MOD2019/0585

PROJECT
TWO SEMI-DETACHED DWELLINGS
WITH BASEMENT CARPARKING:

52 LAUDERDALE AVENUE,
FAIRLIGHT, NSW

S4.55 AMENDMENTS:

GROUND FLOOR PLAN

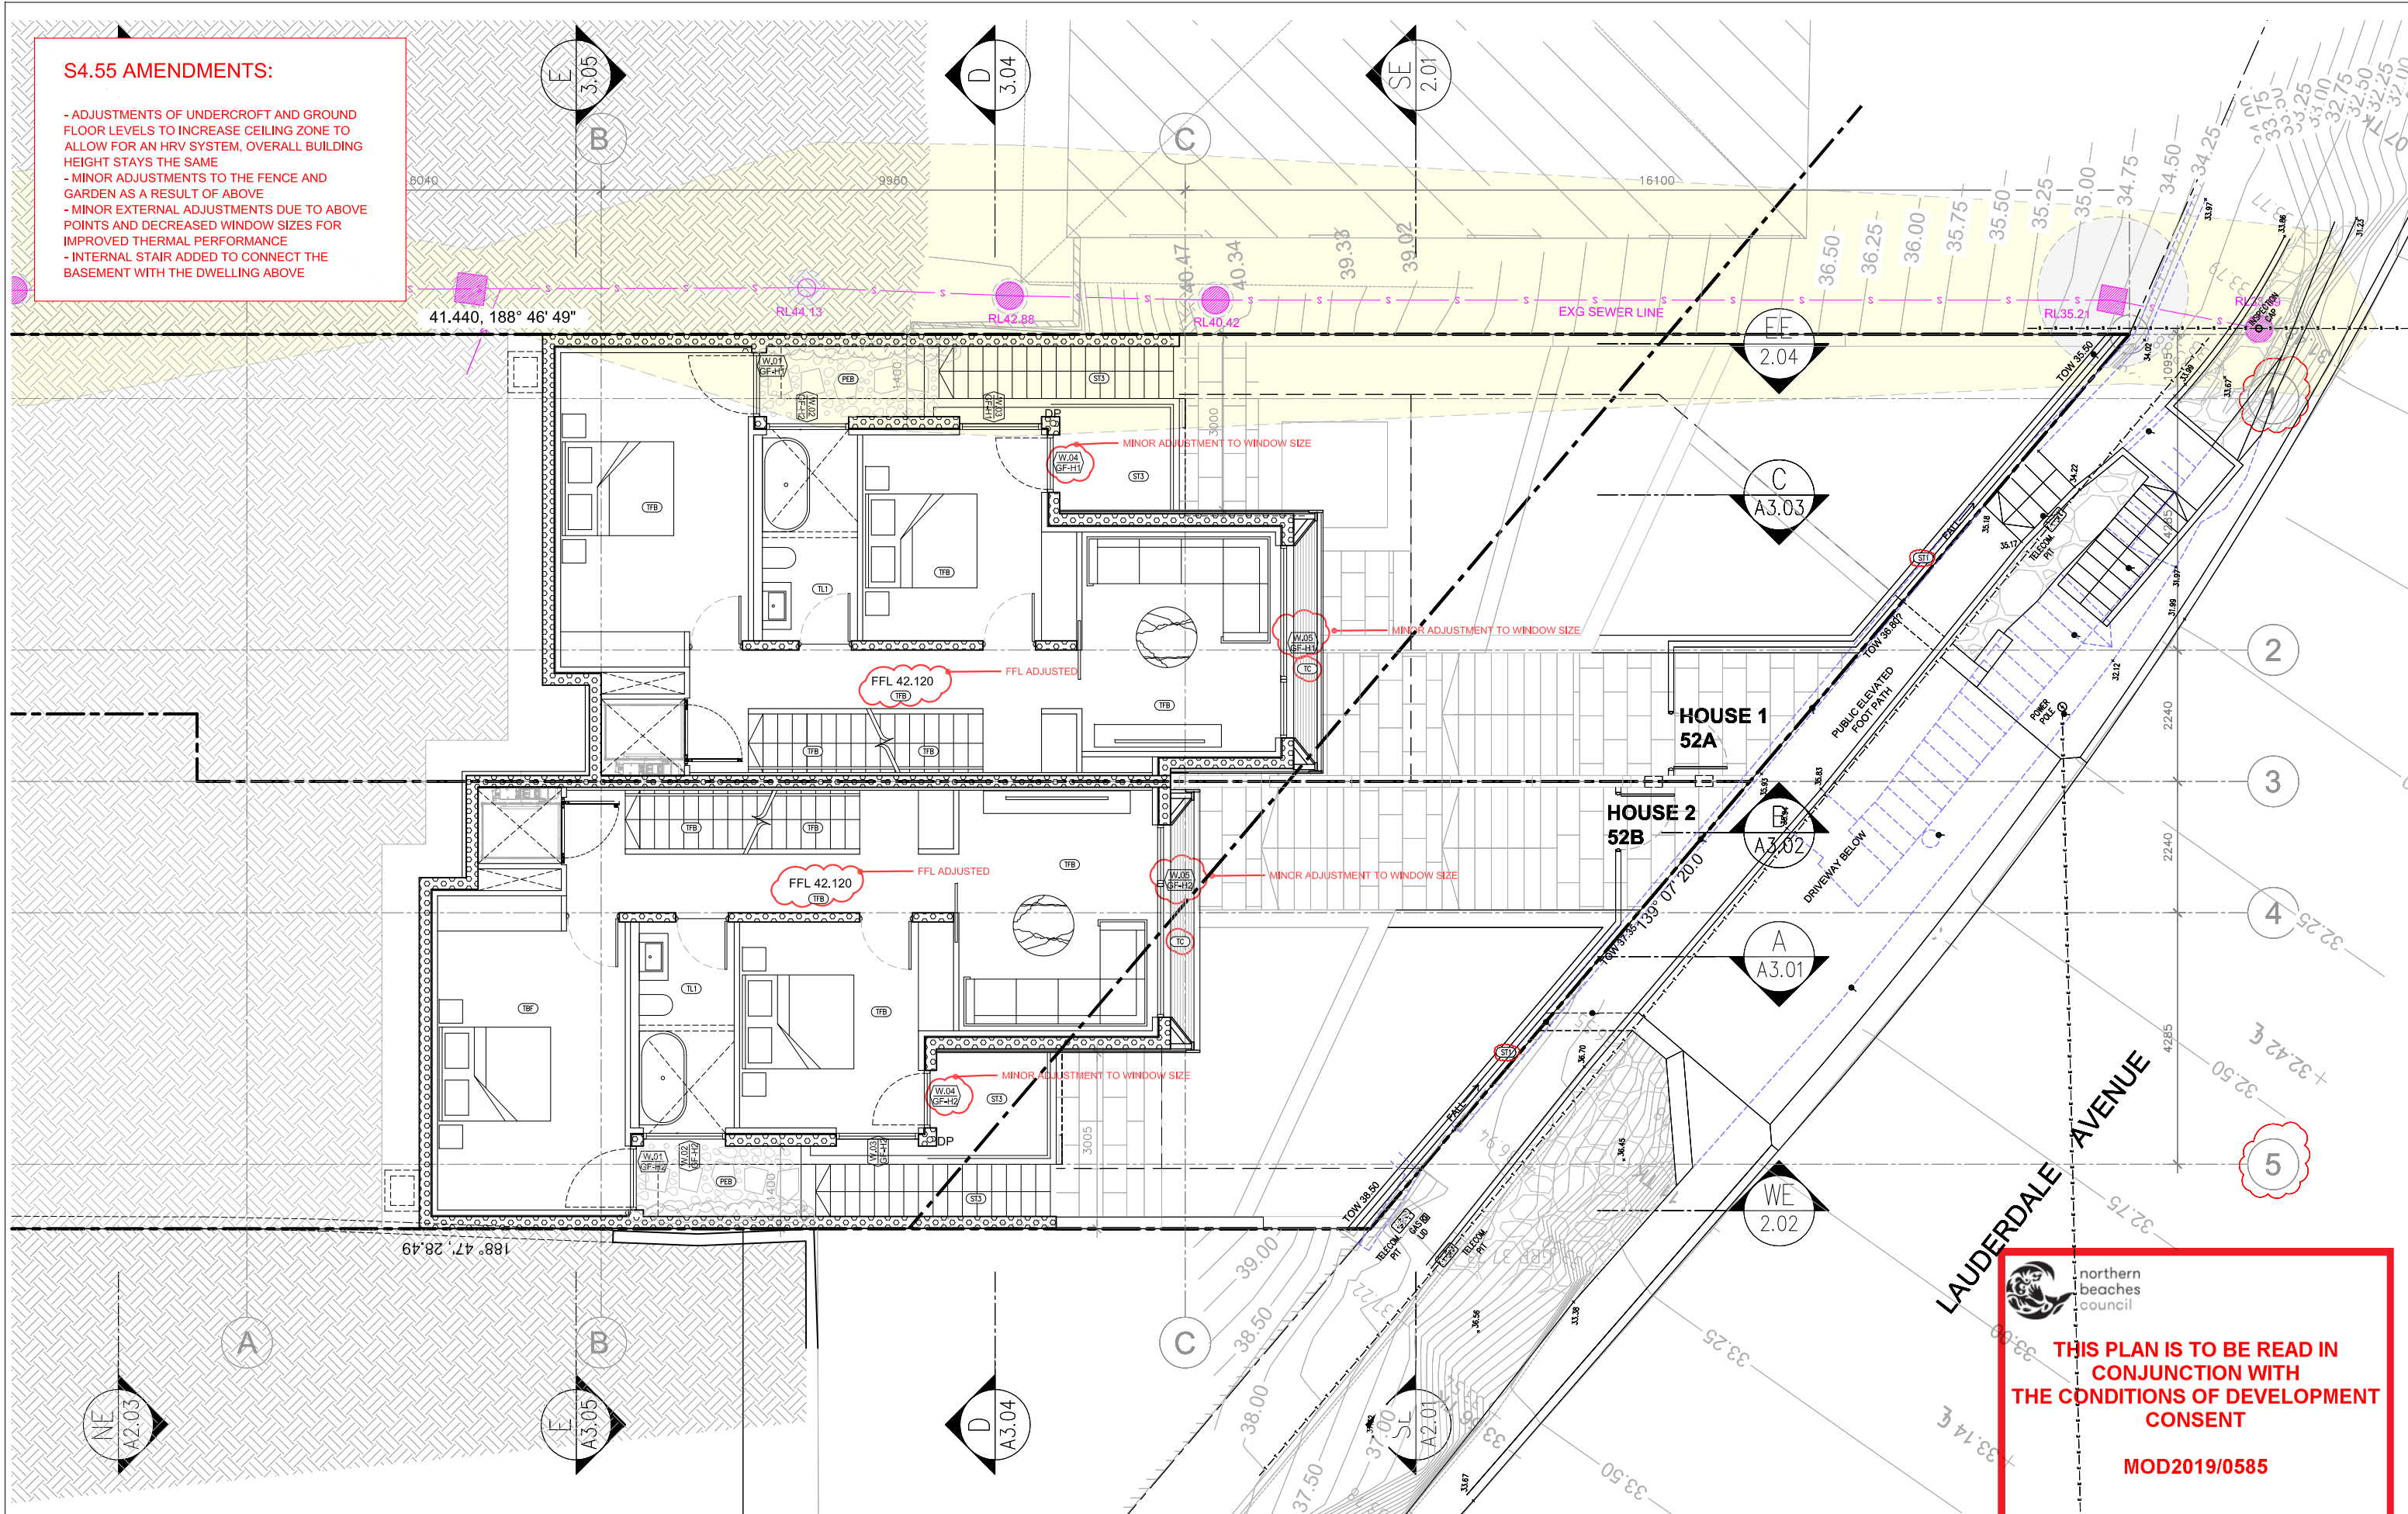
- ADJUSTMENTS OF UNDERCROFT AND GROUND FLOOR LEVELS TO INCREASE CEILING ZONE TO ALLOW FOR AN HRV SYSTEM, OVERALL BUILDING HEIGHT STAYS THE SAME
- MINOR ADJUSTMENTS TO THE FENCE AND GARDEN AS A RESULT OF ABOVE
- MINOR EXTERNAL ADJUSTMENTS DUE TO ABOVE POINTS AND DECREASED WINDOW SIZES FOR IMPROVED THERMAL PERFORMANCE
- INTERNAL STAIR ADDED TO CONNECT THE BASEMENT WITH THE DWELLING ABOVE

DRAWING TITLE
SECOND FLOOR PLAN

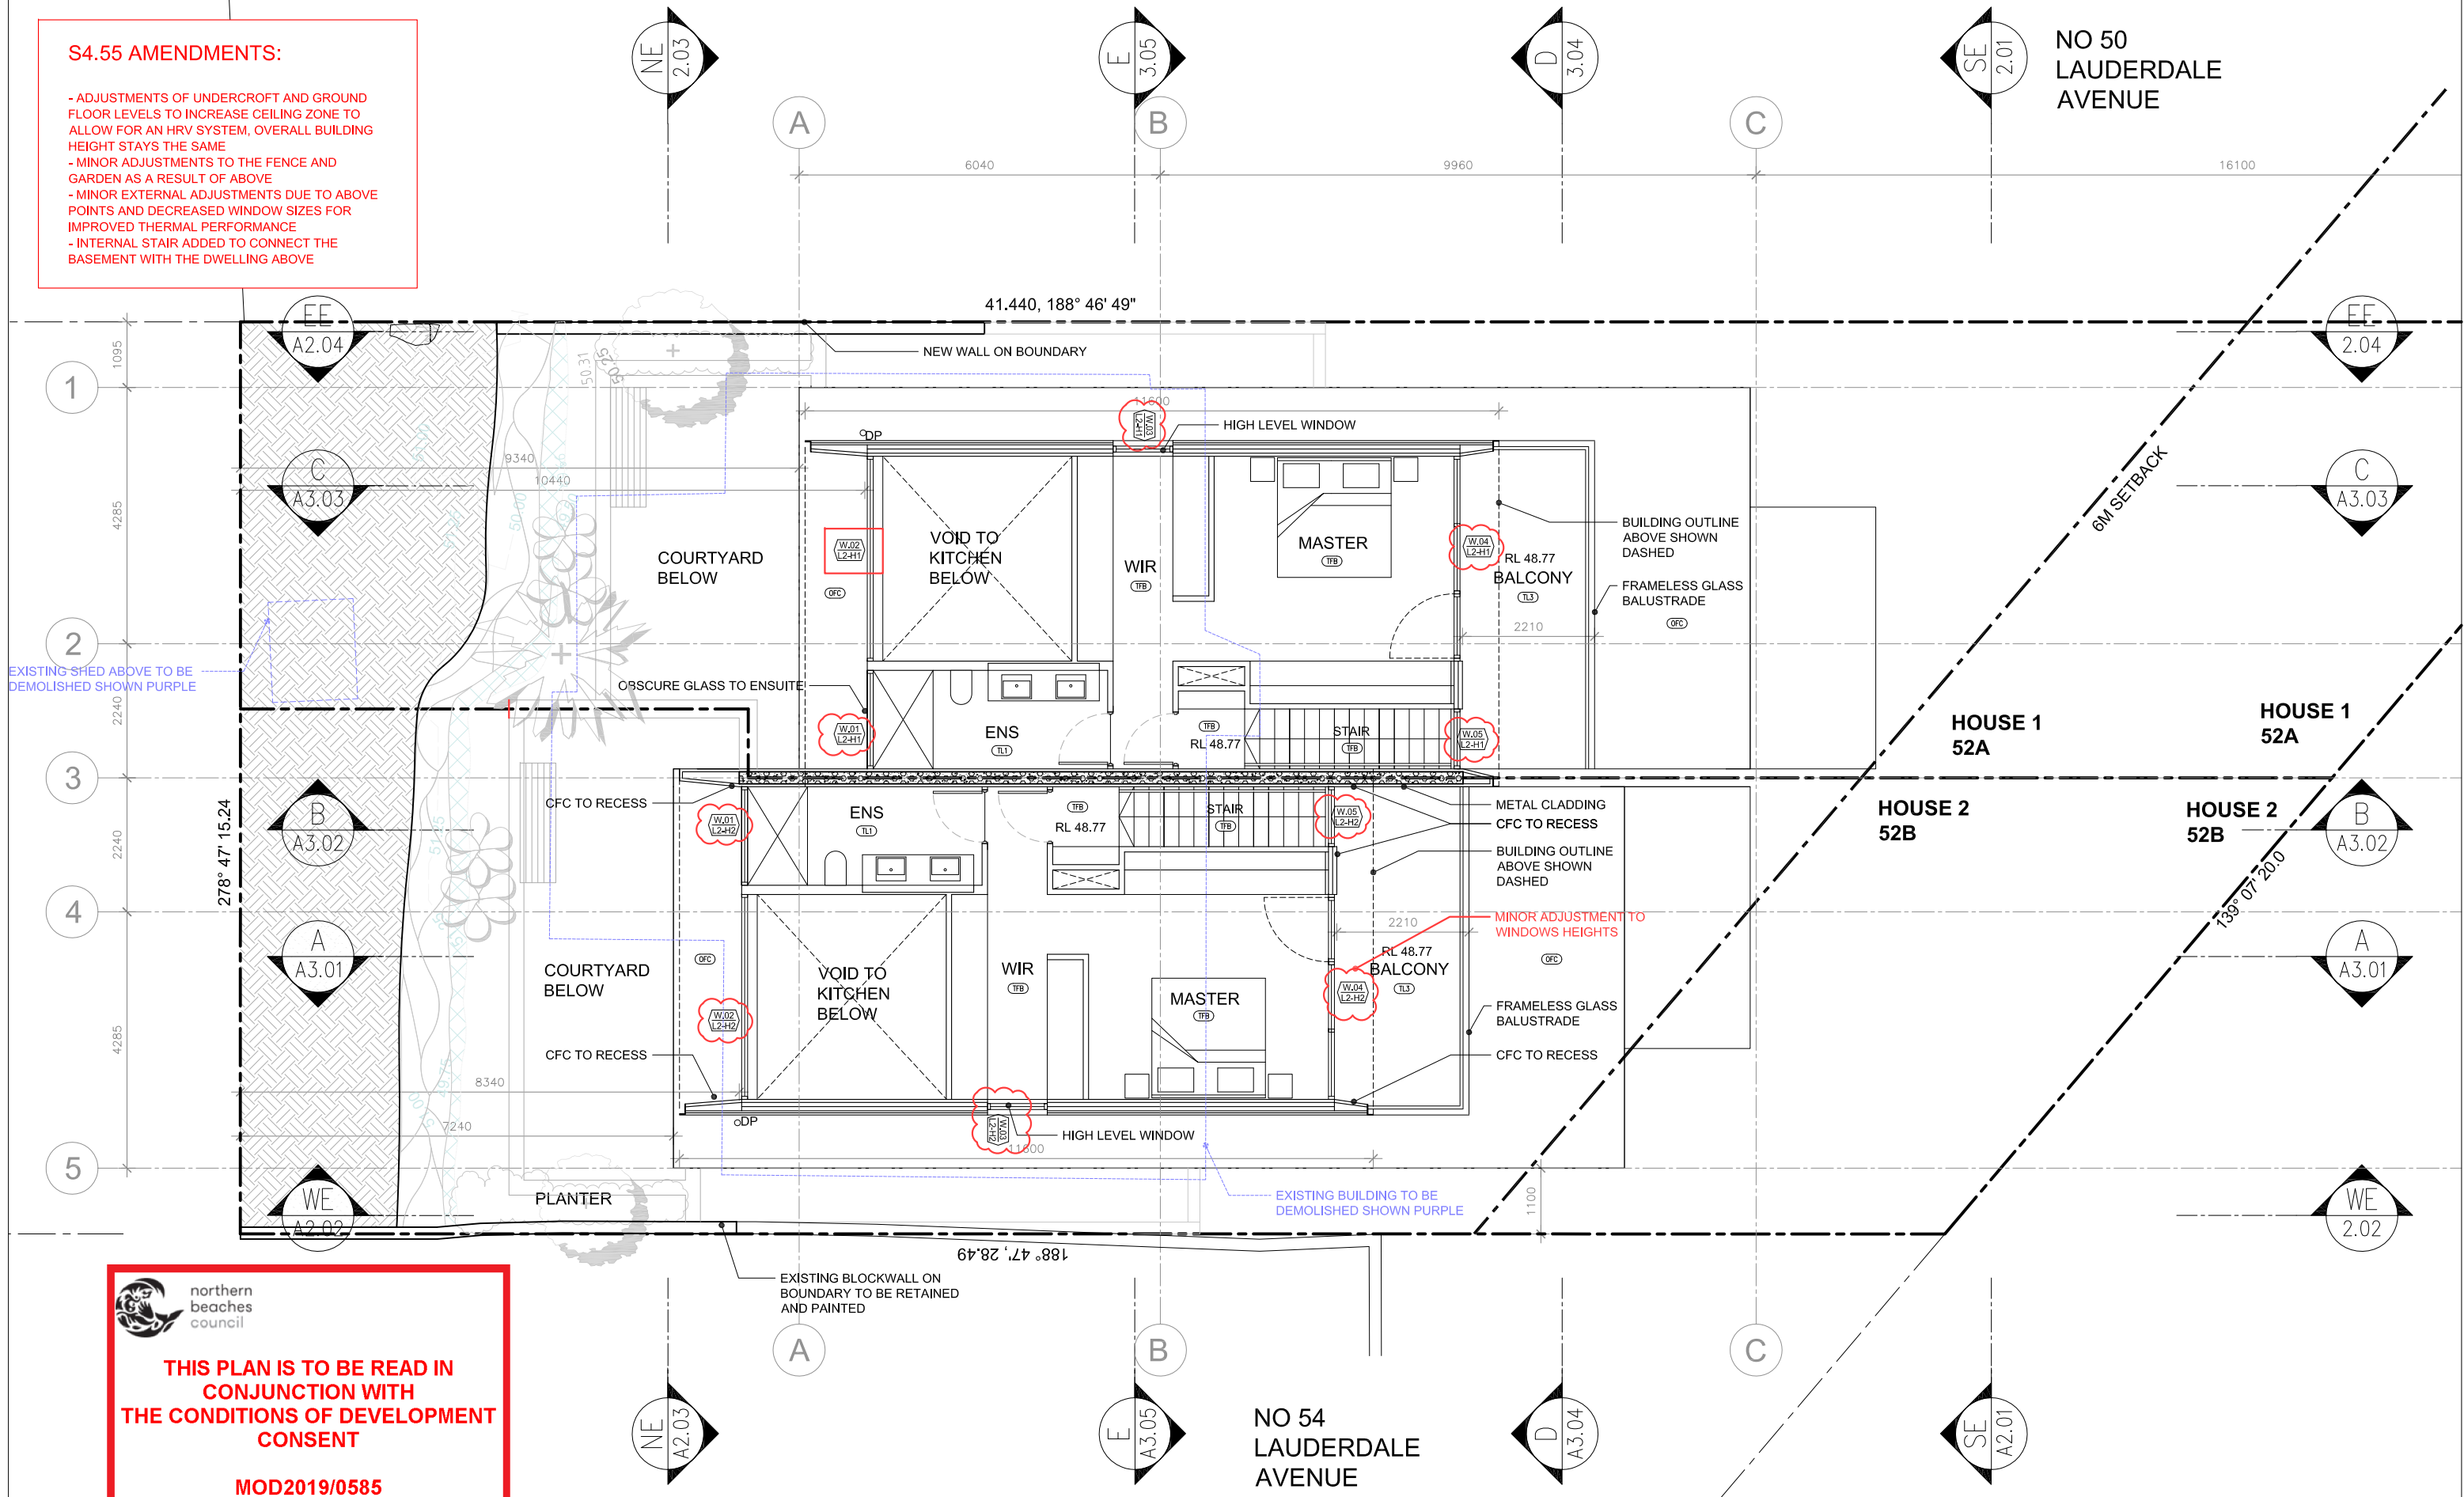
- ADJUSTMENTS OF UNDERCROFT AND GROUND FLOOR LEVELS TO INCREASE CEILING ZONE TO ALLOW FOR AN HRV SYSTEM, OVERALL BUILDING HEIGHT STAYS THE SAME
- MINOR ADJUSTMENTS TO THE FENCE AND GARDEN AS A RESULT OF ABOVE
- MINOR EXTERNAL ADJUSTMENTS DUE TO ABOVE POINTS AND DECREASED WINDOW SIZES FOR IMPROVED THERMAL PERFORMANCE
- INTERNAL STAIR ADDED TO CONNECT THE BASEMENT WITH THE DWELLING ABOVE

DRAWING TITLE		PROJECT	
SOUTH ELEVATION		LAF	
SCALE	STATUS	NUMBER	REVISION
1:100 @A3	s4.55	A2.01	S4.55

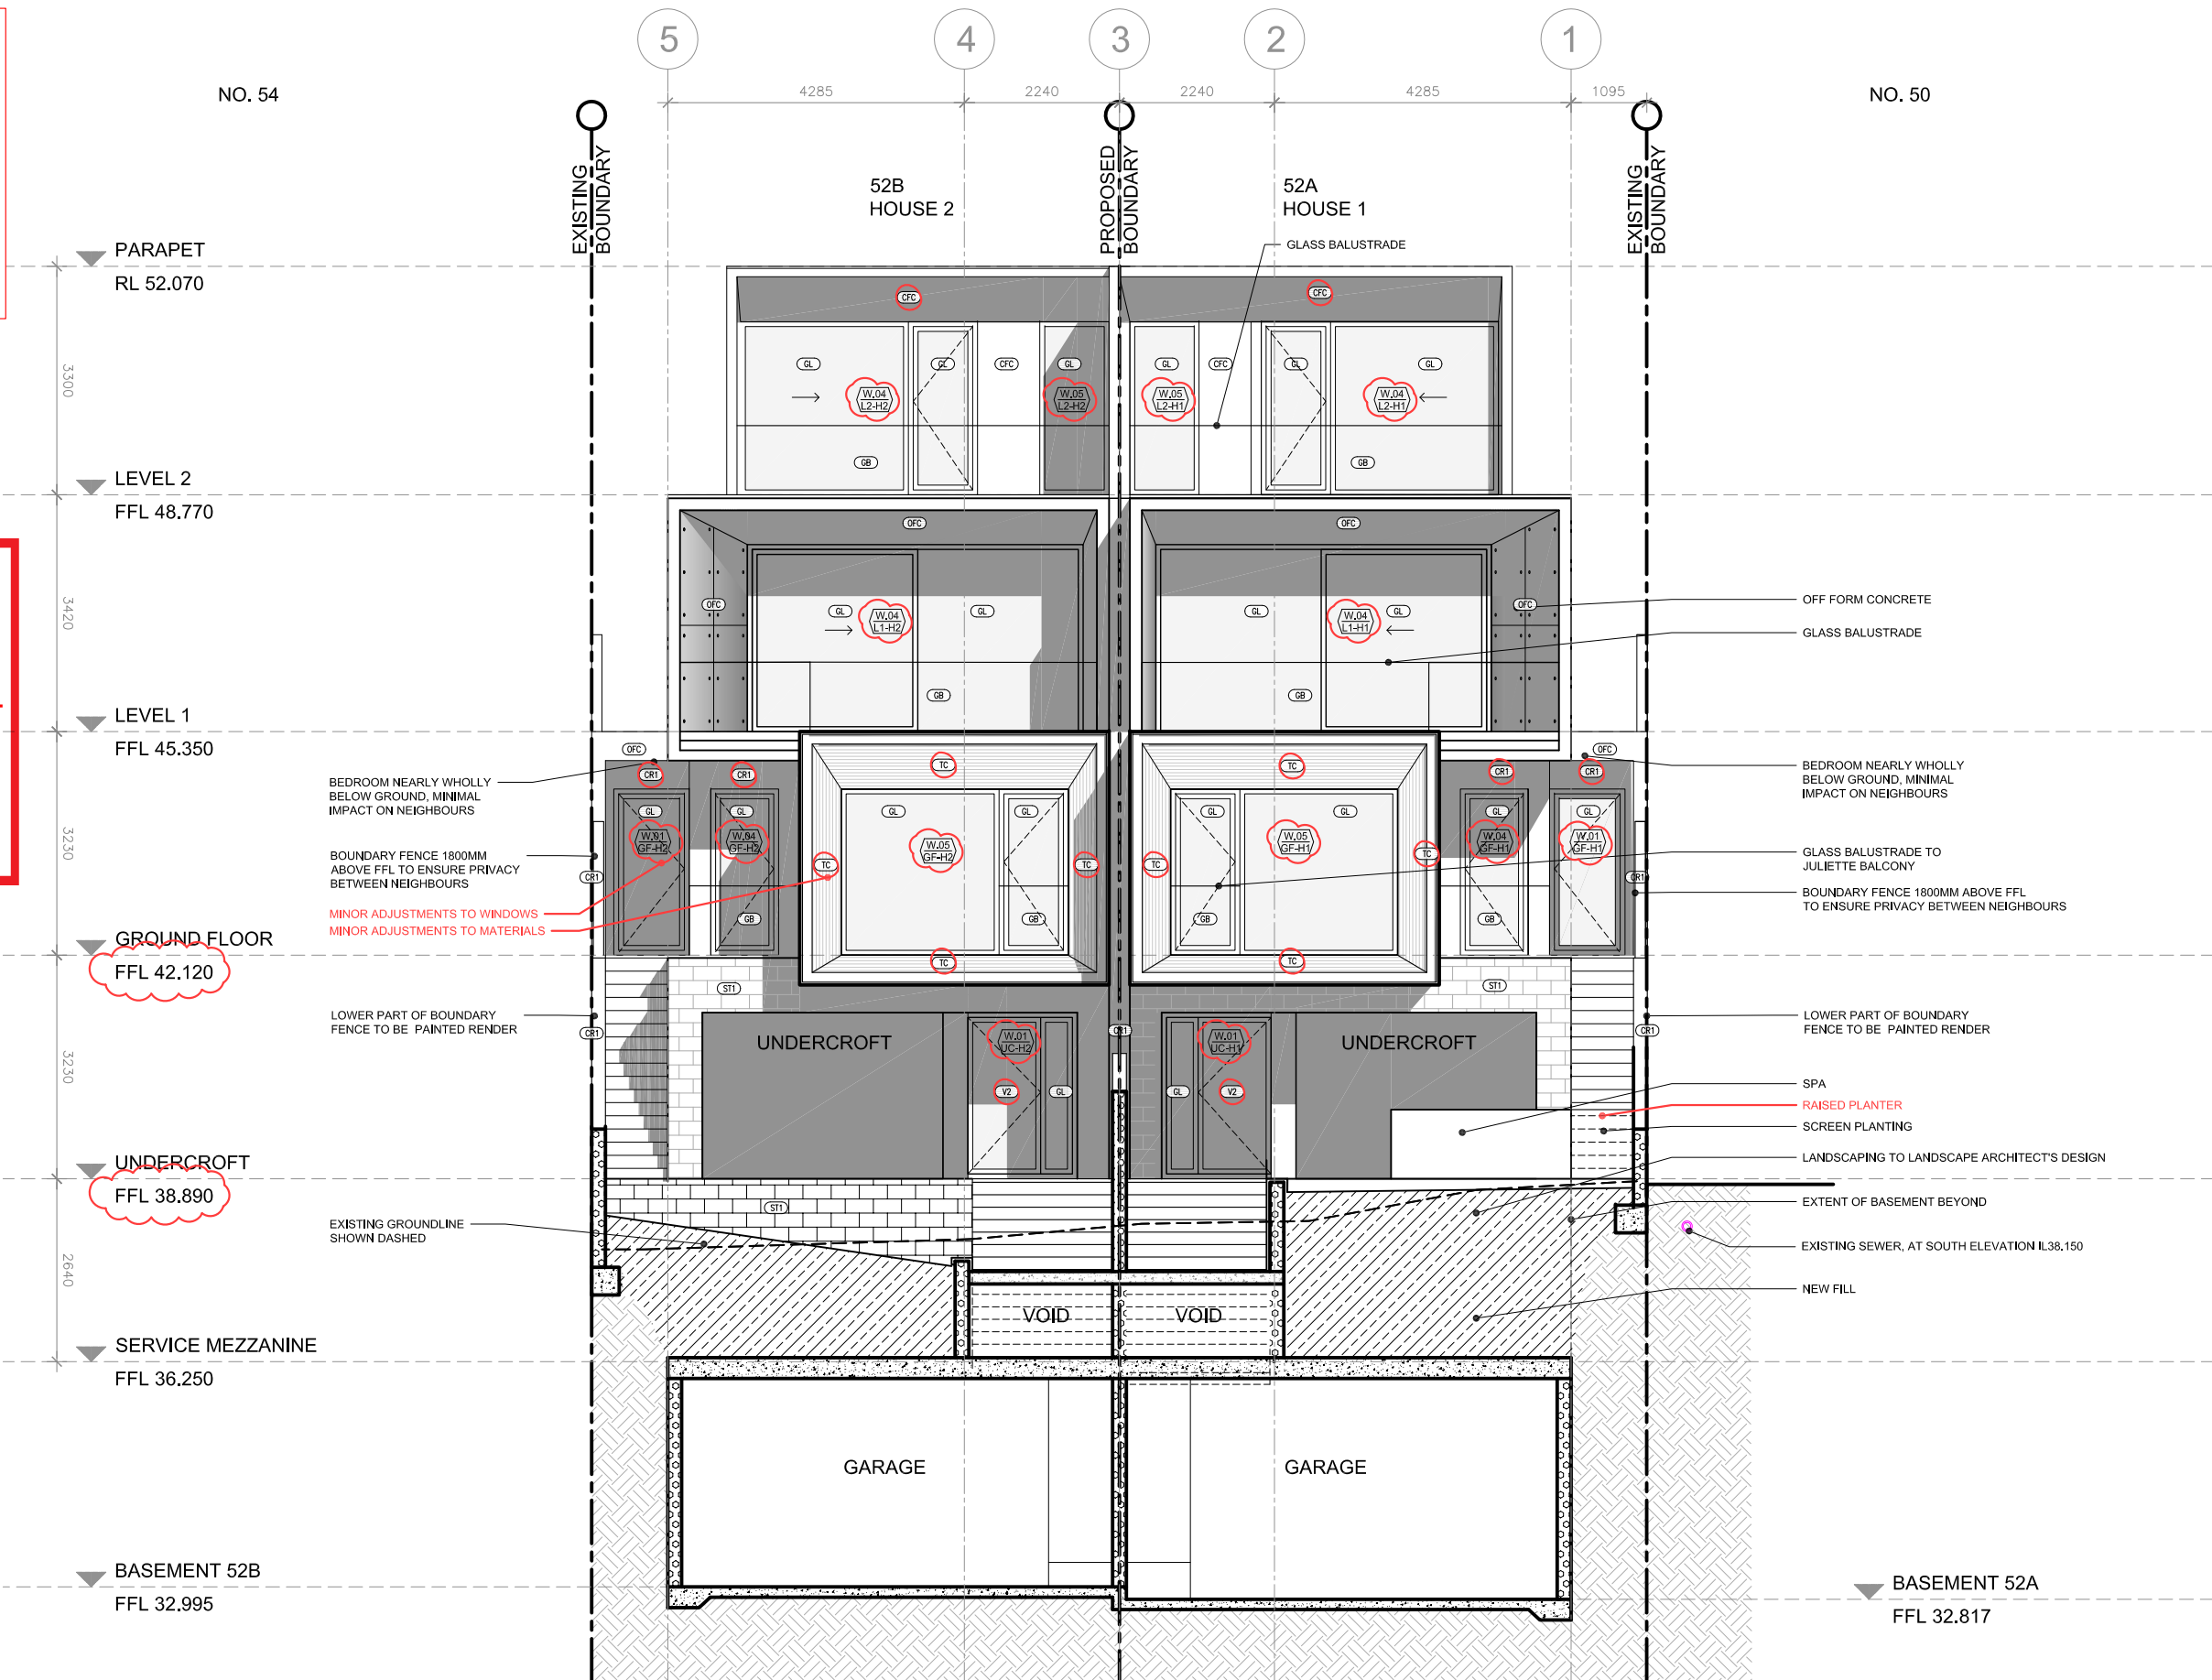
- ADJUSTMENTS OF UNDERCROFT AND GROUND FLOOR LEVELS TO INCREASE CEILING ZONE TO ALLOW FOR AN HRV SYSTEM, OVERALL BUILDING HEIGHT STAYS THE SAME
- MINOR ADJUSTMENTS TO THE FENCE AND GARDEN AS A RESULT OF ABOVE
- MINOR EXTERNAL ADJUSTMENTS DUE TO ABOVE POINTS AND DECREASED WINDOW SIZES FOR IMPROVED THERMAL PERFORMANCE
- INTERNAL STAIR ADDED TO CONNECT THE BASEMENT WITH THE DWELLING ABOVE
